Re: Request to amend certificate of authorization to include additional lands on the right bank
 Innavik Hydroelectric Project, Inukjuak
 N/Ref: 3215-10-005

Re: Excavation of hydroelectric station site, tailrace and headrace of the Innavik Hydroelectric Project – Rerouting of tailrace, relocation of sedimentation ponds and addition of a work and storage area

Re: Amendment to authorization for the construction of an access road as well as storage and work areas
 – Innavik Project

Carte 1 Plan de localisation des modifications

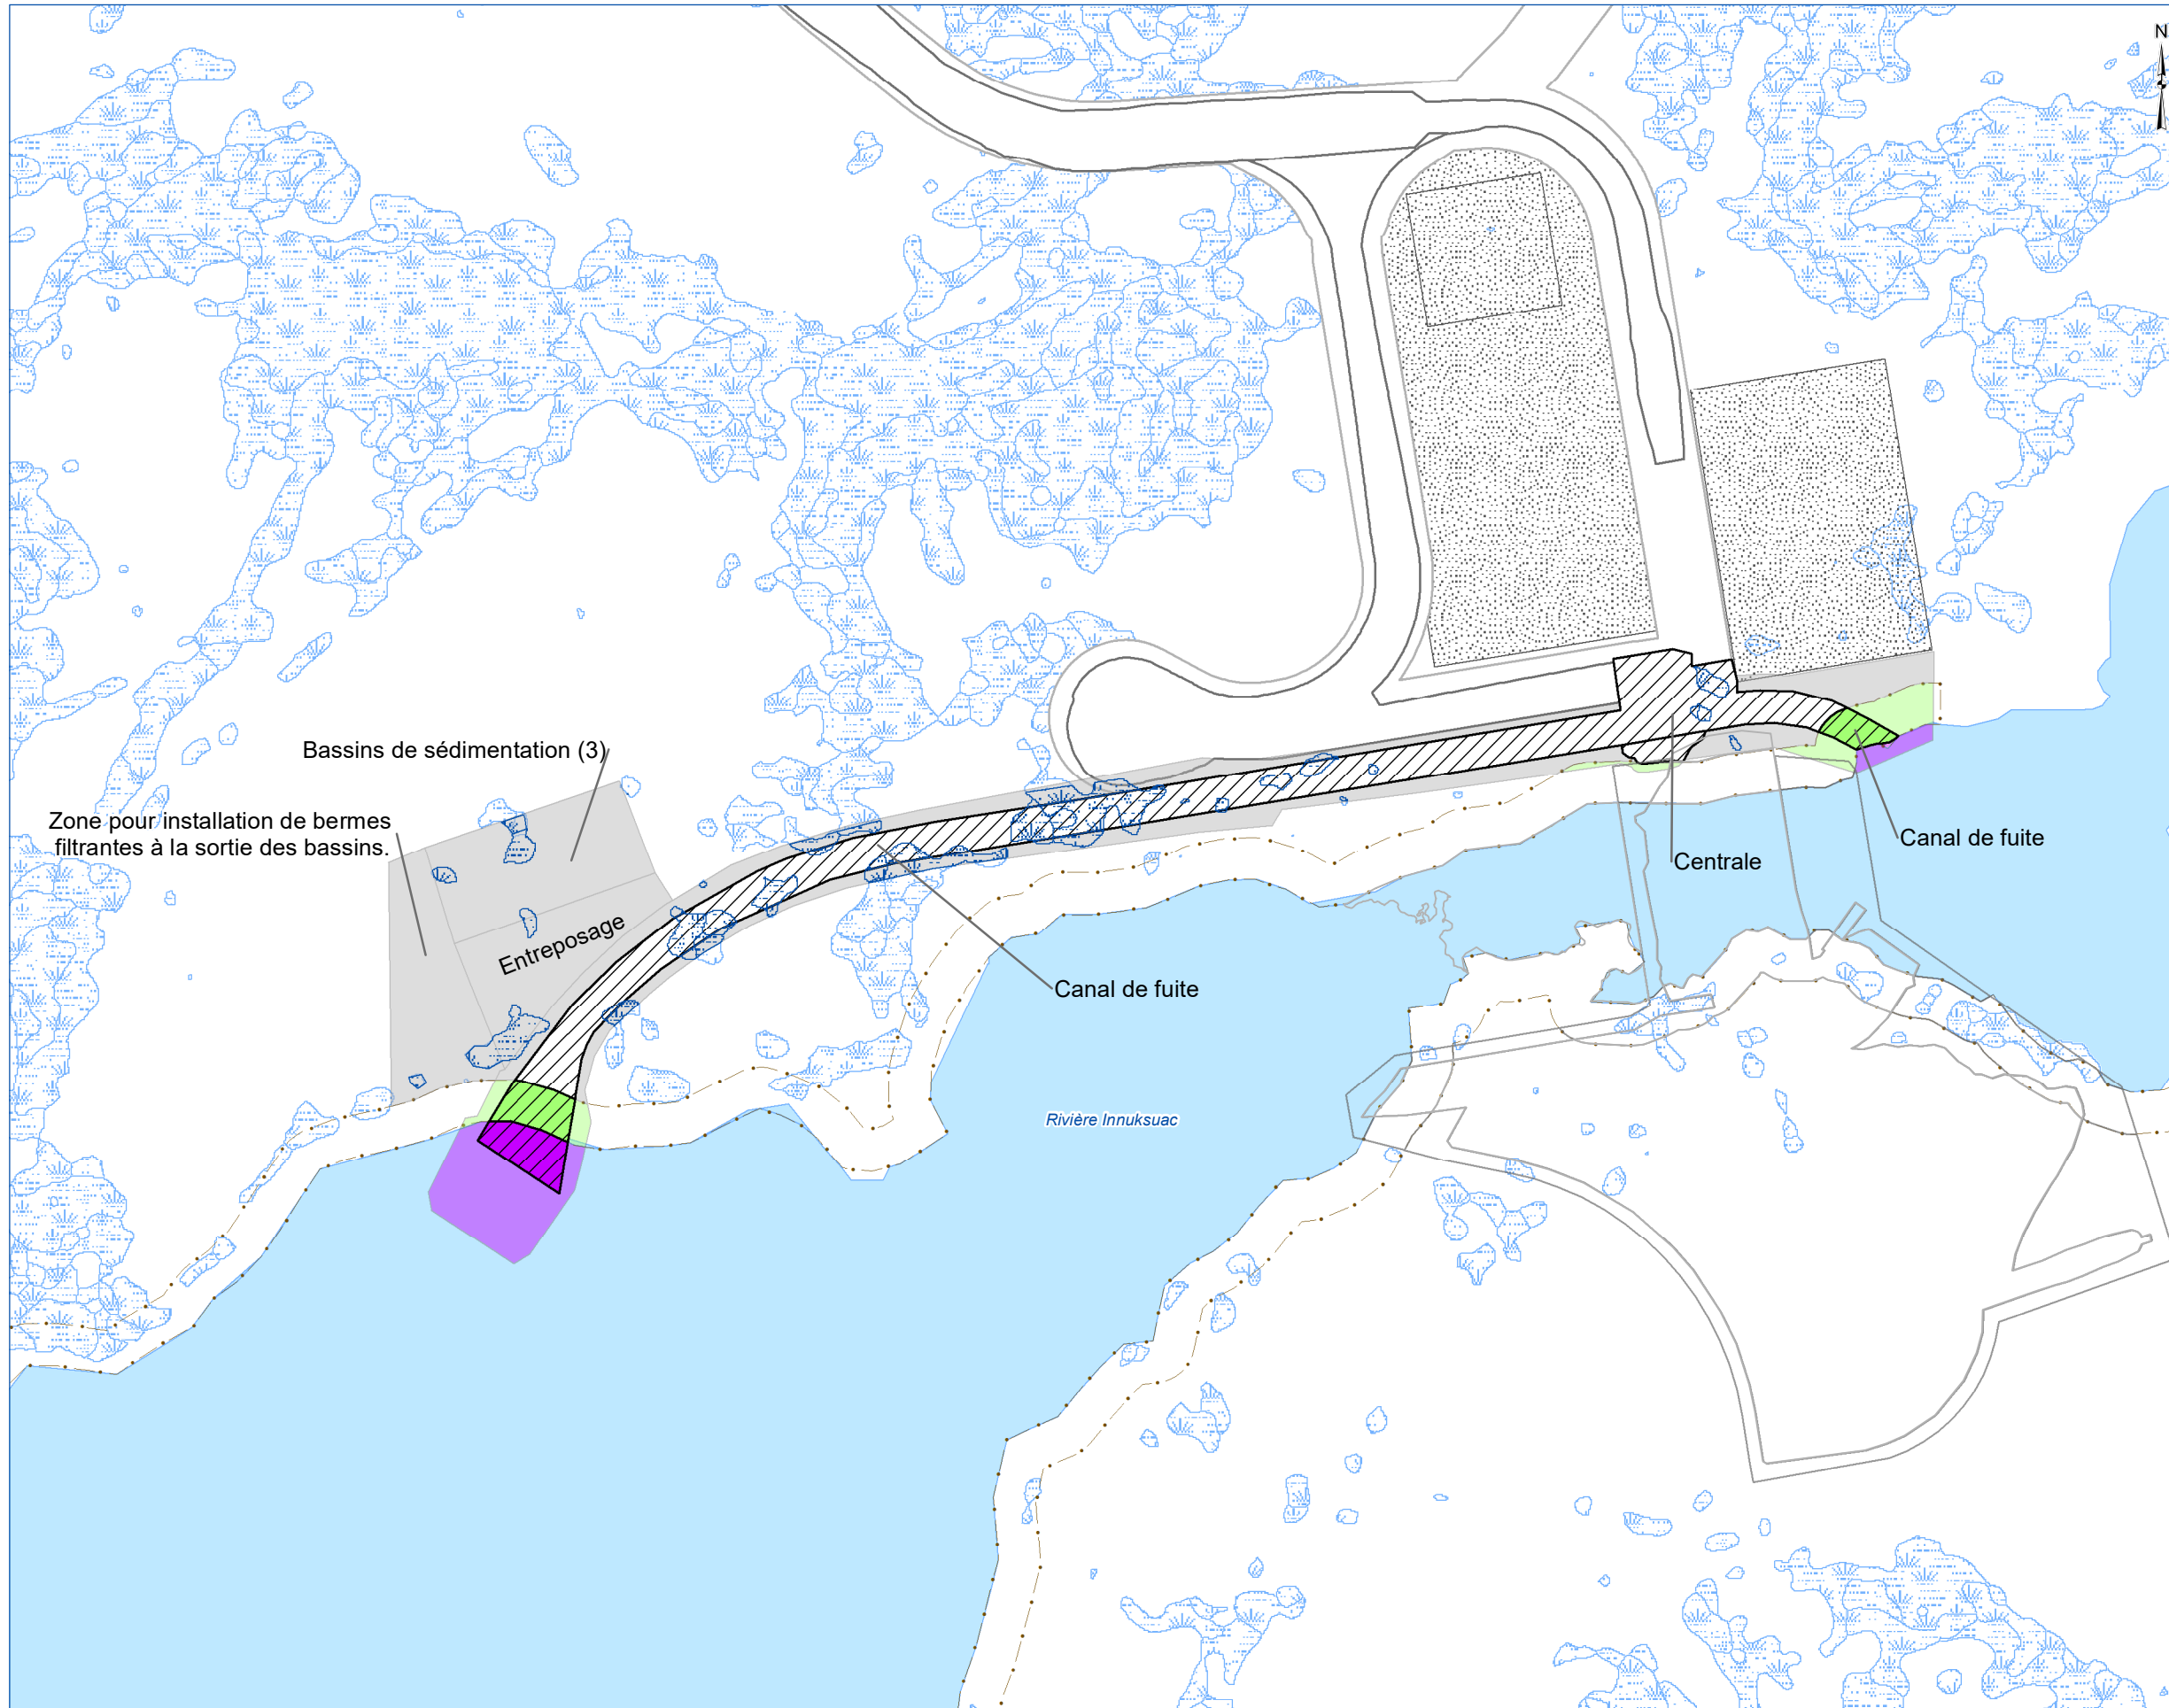
The first modification consists of enlarging and slightly relocating the backfill storage area on the right bank. This area was indicated as measuring 18,081.9 m² in the authorization application. It needs to be enlarged to 24,679.3 m² in order to allow for the safe storage of dynamited rock from the excavation of the dam site. The entire storage area will be maintained following completion of the work phase for the permanent storage of dynamited rock.

The storage area must also be slightly relocated to respect the natural topology of the land (see Location Map in the Appendix). All mitigation measures presented in the application will be maintained, namely the installation of a geotextile membrane for erosion and sediment management and the creation of sediment traps. Catchment basins will be created to capture runoff at low points.

The second modification consists of enlarging the access area. An area measuring 6,046 m² will have to be added to the existing access area (7,460 m²) for a total surface area of 13,506 m². This enlargement is necessary due to a lack of space at the work site and in order to allow for the safe circulation of vehicles on

Carte 1 Excavation en rive nord - Modification des emprises de travaux en milieux humide et hydrique

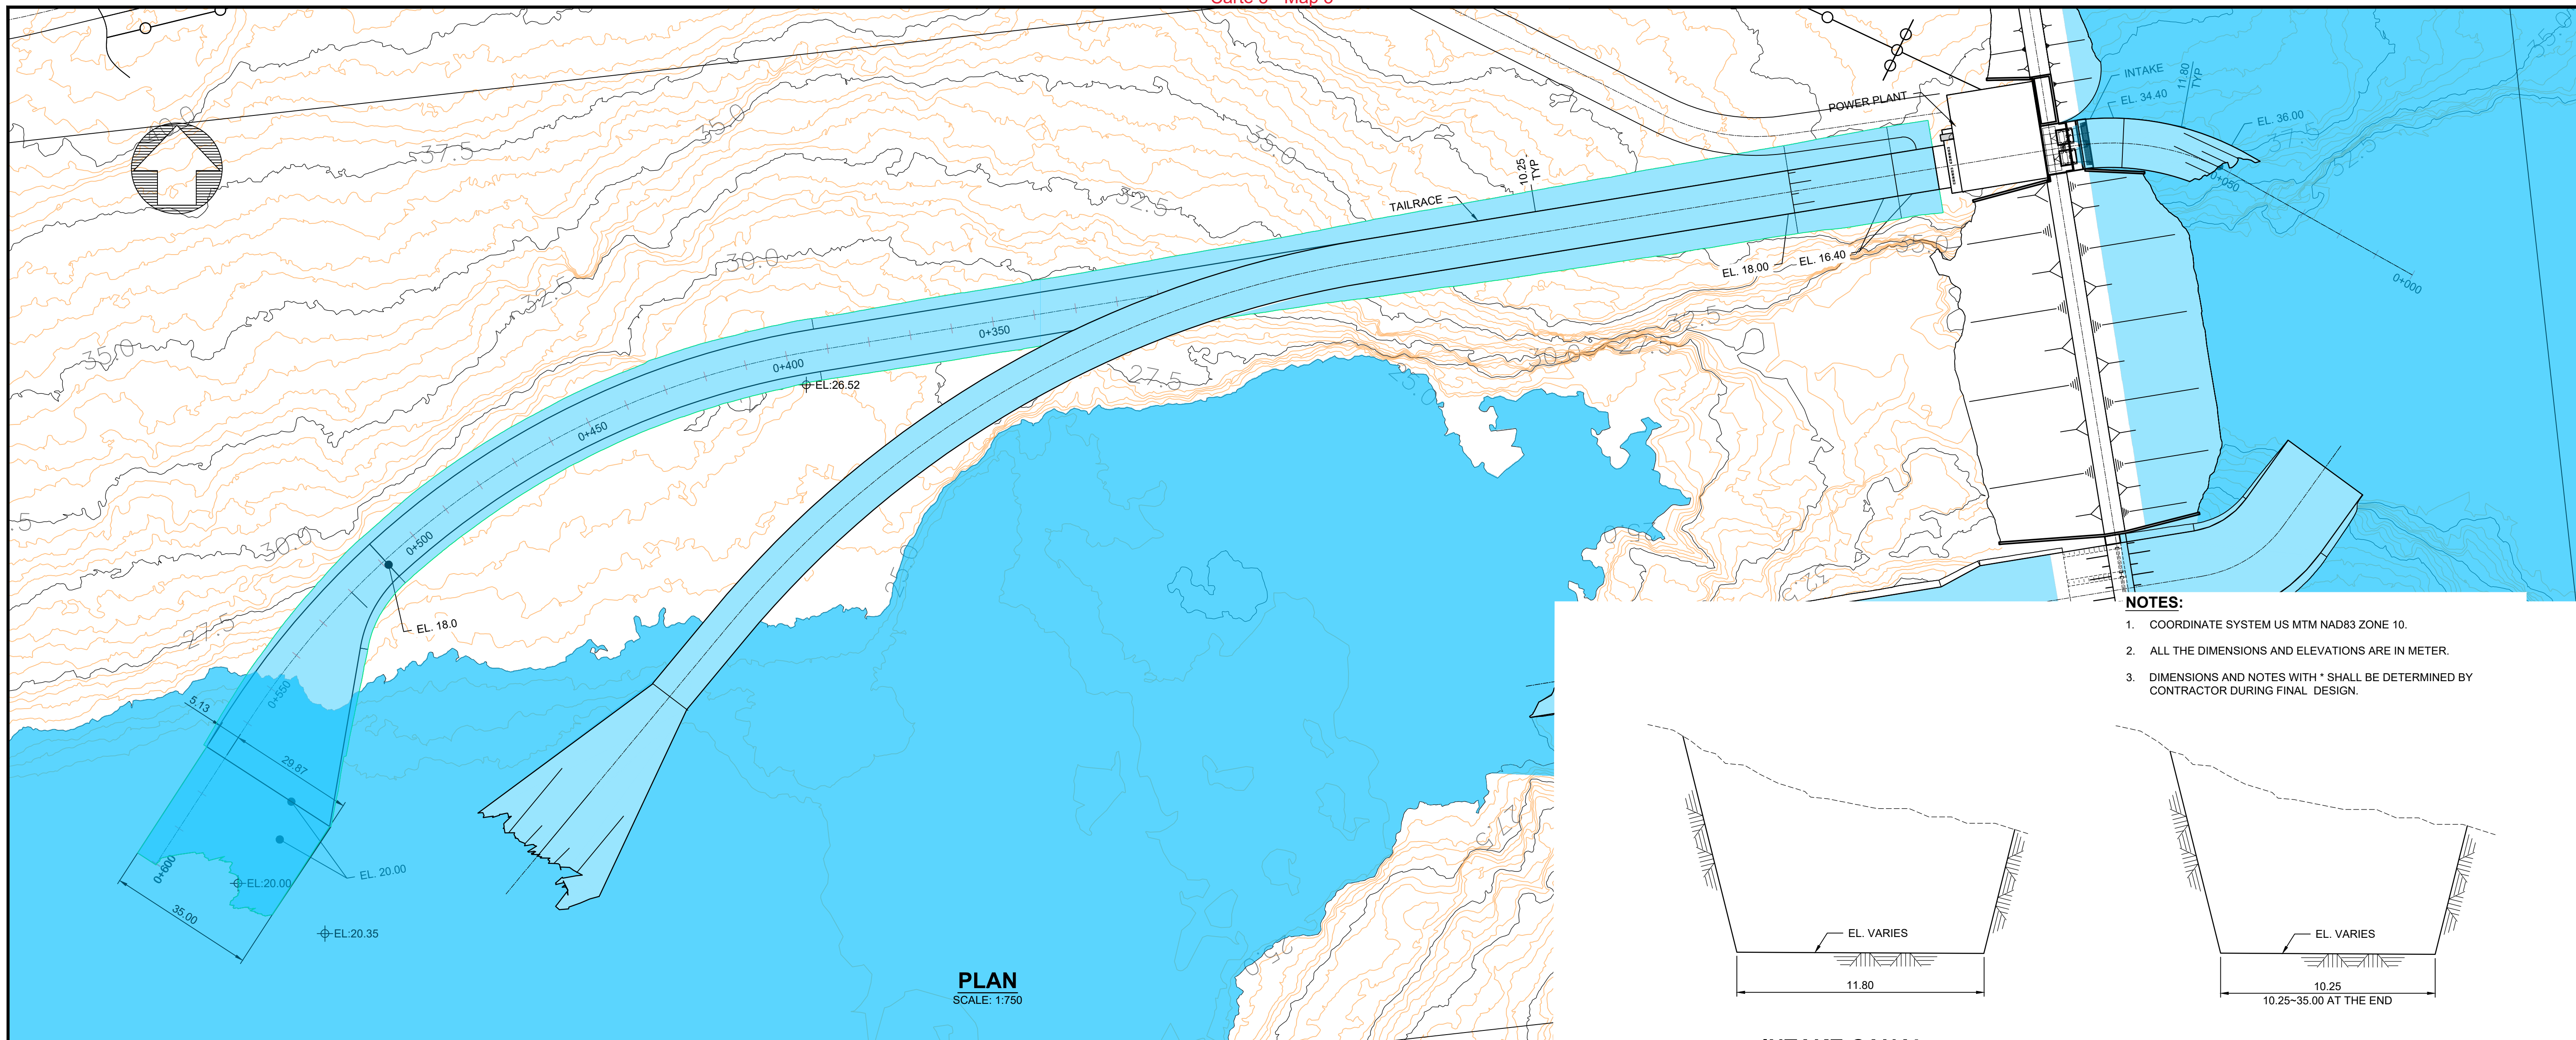
The tailrace will be rerouted so that its outlet is farther downstream; it is therefore correspondingly longer. The modification is presented in the enclosed plan and in Map 1. The surface area of the rerouted tailrace is increased to 6,083.8 m².

The sedimentation ponds that were initially to be created in the tailrace right-of-way will be relocated to the side of the said right-of-way. In fact, the volume of water from excavations is less than initially planned, hence the need to site the ponds outside the tailrace excavation area. Three sedimentation ponds will be constructed and will occupy an area measuring 2,670 m². Moreover, filter berms occupying a surface area of 2,304 m² will be constructed to reduce flow velocity and thus any soil erosion that might be triggered by water flowing from the ponds. This surface area (see Map 1) will be used temporarily and will be restored after the work has been completed.

Between the tailrace and the pond area, a work and storage area spanning 2,091.3 m² will be created. This area will also be temporary.

<p>JOINT VENTURE</p>		<p>DESIGNER</p>
<p>INNAVIK HYDROELECTRIC PROJECT INTAKE AND TAILRACE WATERWAY</p>		
FILE No.	PROJECT No.	
INK-tailrace-2e-3(W10.25+EL18).dwg	81.XX	
DRAWING No.	FIGURE 3.0	D

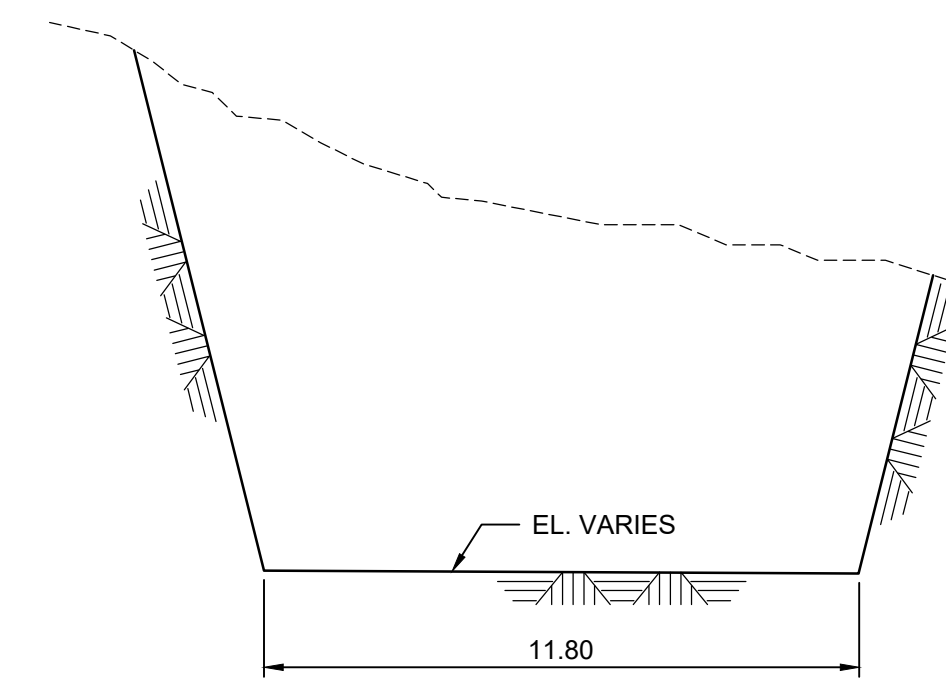
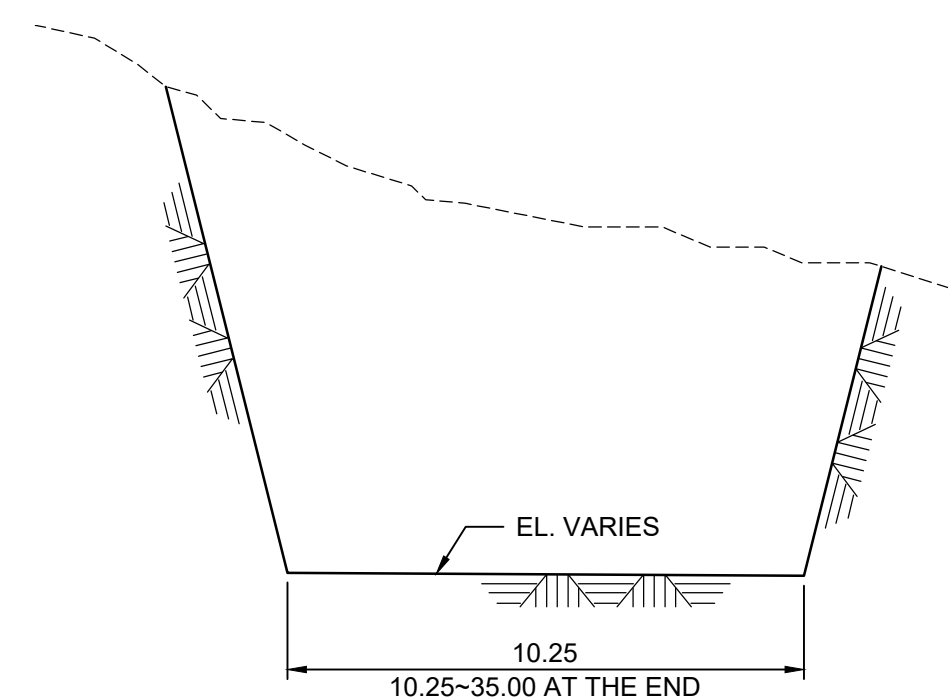
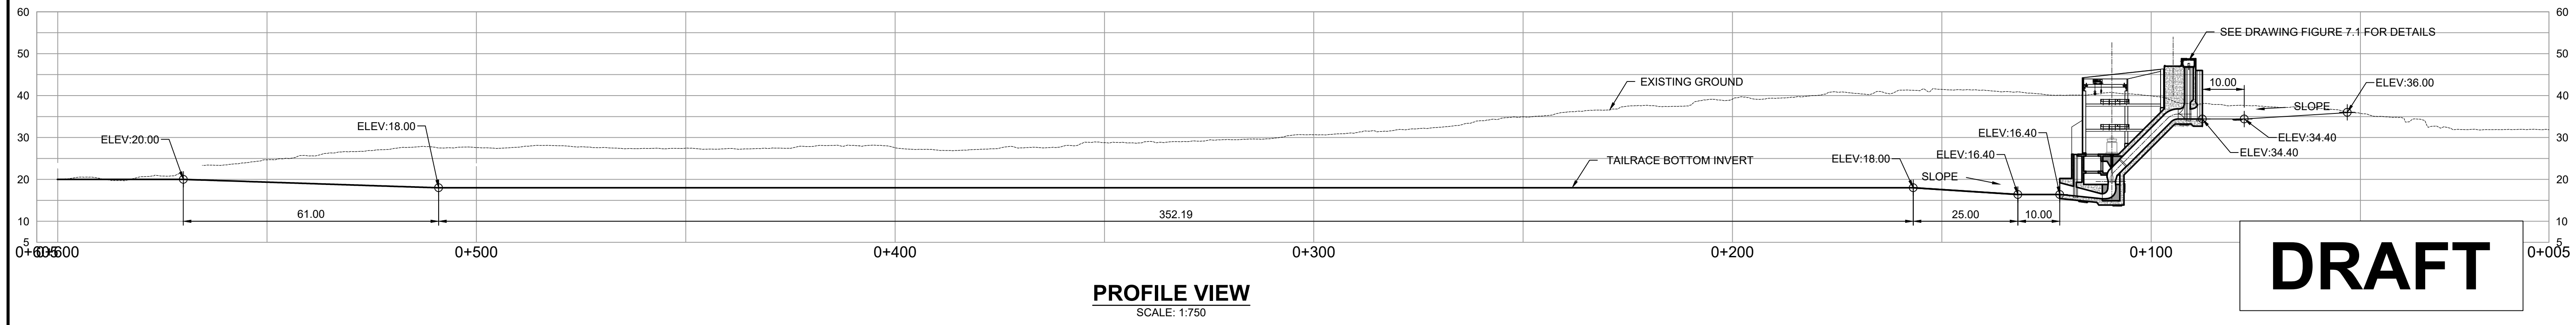
The tailrace area, covering 4,707 m², was authorized on July 10, 2020 (N/Ref: 7430-10-01-10031-02, 401935683). The tailrace's path has been modified so that its outlet is moved further downstream because the overburden was not suitable for tailrace construction (maps 2 and 3). Therefore, the tailrace area is expanded to a total of 6,084 m².
